***DOCKET ITEM #15******Special Use Permit # 2018-0067******1501, 1503, 1505 Mount Vernon Avenue – Charlie's on the Avenue***

Application	General Data	
	Planning Commission Hearing:	September 4, 2018
	City Council Hearing:	September 15, 2018
Public hearing and consideration of a request for a special use permit amendment to add outdoor seating and extend the hours of operation at an existing restaurant.		
Address: 1501-1505 Mount Vernon Avenue	Zone:	CL / Commercial Low
Applicant: NOVA Hospitality, LLC, represented by M. Catherine Puskar, attorney	Small Area Plan:	Potomac West

Staff Recommendation: *PARTIAL APPROVAL* subject to compliance with all applicable codes and ordinances and the recommended permit conditions found in Section III of this report.

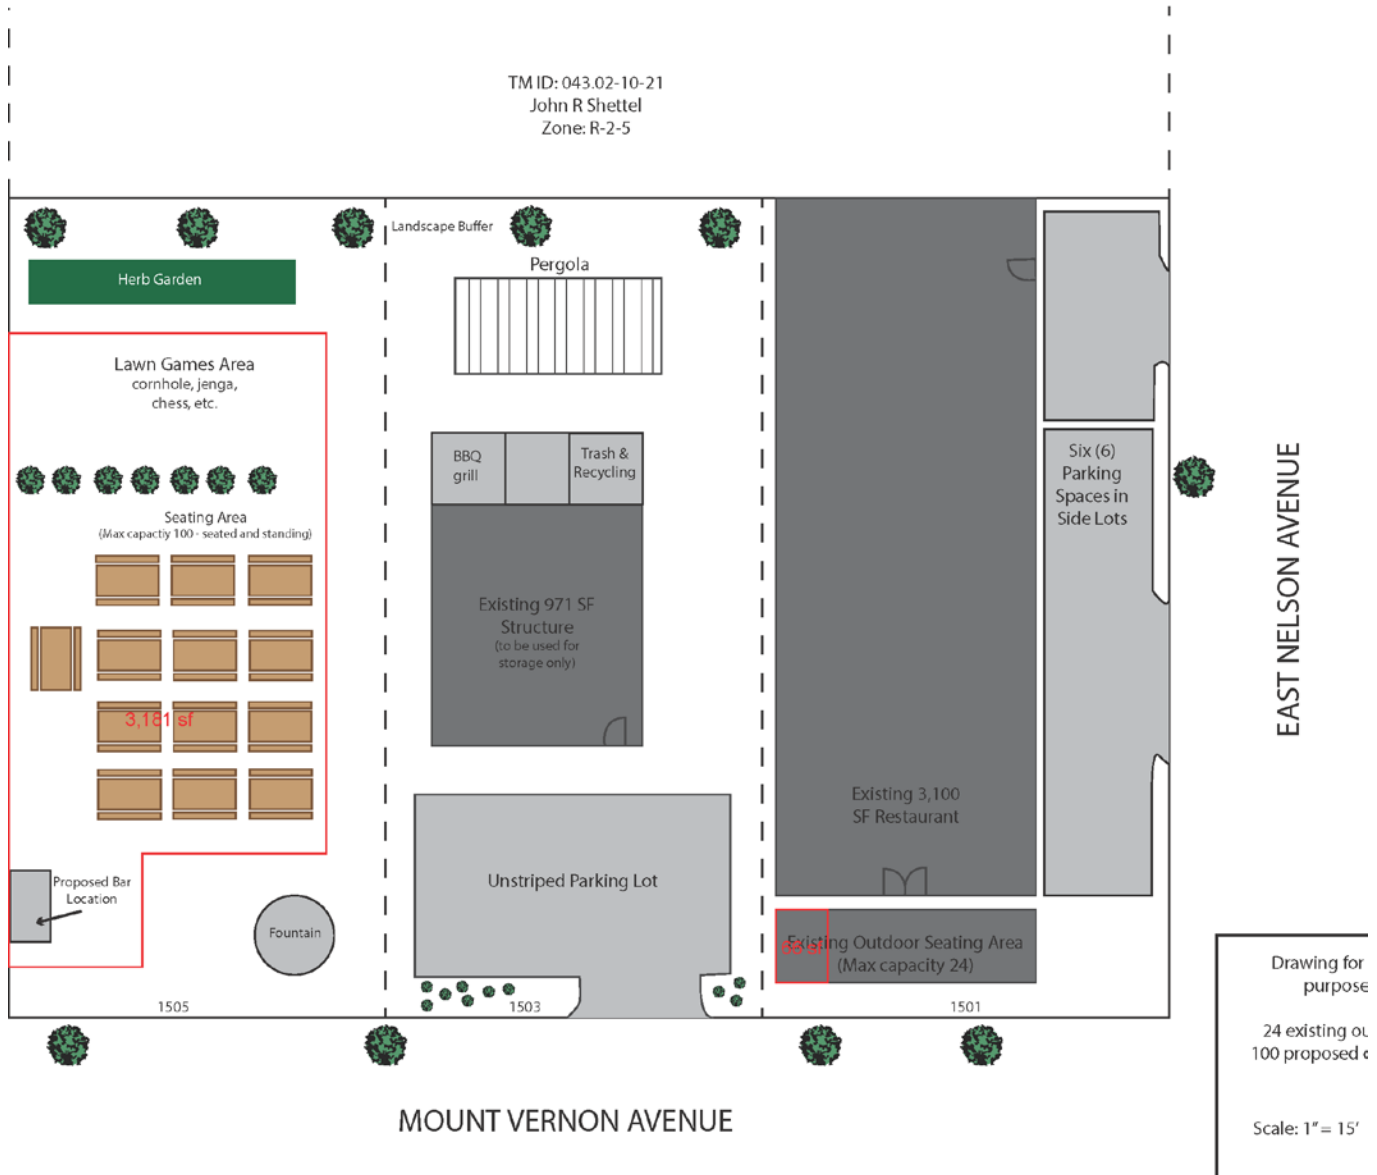
Staff recommends approval of 80 outdoor dining seats (Condition #2) as opposed to the 124-additional outdoor dining seat proposal. This would provide the applicant with 16 outdoor seats at 1501 Mount Vernon, and the remaining 64 seats at 1505 Mount Vernon Avenue, which is slightly more than the next largest outdoor dining area at Evening Star with a total of 50 outdoor dining seats. Although the majority of restaurants along Mount Vernon Avenue have 20 outdoor dining seats (the exception being the Evening Star with 50 and Los Tios Grill with 62 outdoor dining seats), staff recognizes the size of the applicant's two lots provides more space than available in front of the smaller storefront restaurants where 20 seats are customary. Staff has included a restriction on the number of standing and seated patrons to 16 at 1501 Mount Vernon Avenue, and 64 patrons at 1503-1505 Mount Vernon Avenue.

Staff also recommends that the outdoor dining and other associated outdoor activities, be set back from the rear property line 45 feet (Condition #37), and that the applicant install landscaping to provide a visual buffer from the residential property to the rear (Condition #37). Though a staff analysis of outdoor dining setbacks adjacent to residential properties shows a 72-foot average, the

Staff does not recommend additional outdoor seats beyond 80 total. After completing an analysis on outdoor dining on Mount Vernon Avenue, and taking into consideration the three separate lots under this request, 80 outdoor seats is appropriate when comparing the physical size of the space with the community averages. The recommendation would average to approximately 26 outdoor seats per lot, which is three more seats than what is typical of a restaurant on Mount Vernon Avenue, a reasonable increase from the average.

2. **CONDITION AMENDED BY STAFF:** Indoor seats are limited to 84. Outdoor dining is limited to 16 seated or standing patrons at 1501 Mount Vernon Avenue, and no more than 64 seated or standing patrons at 1503-1505 Mount Vernon Avenue. ~~Seating shall be provided for a total of no more than 100 patrons, including both indoor and outdoor dining areas.~~ (P&Z) (SUP#2004-0045)

37. **CONDITION ADDED BY STAFF:** The outdoor dining and games area on 1503-1505 Mt Vernon Avenue shall be located at least 45 feet from the rear property line and a fence shall be installed across the property from the rear building wall on 1503 Mt Vernon Avenue to the adjacent property at 1509 Mt Vernon Avenue to clearly delineate the patron area. The applicant shall also submit a landscape plan to ensure adequate screening to the adjacent home at 404 East Nelson Avenue, to the satisfaction of the Director of Planning & Zoning. (P&Z)
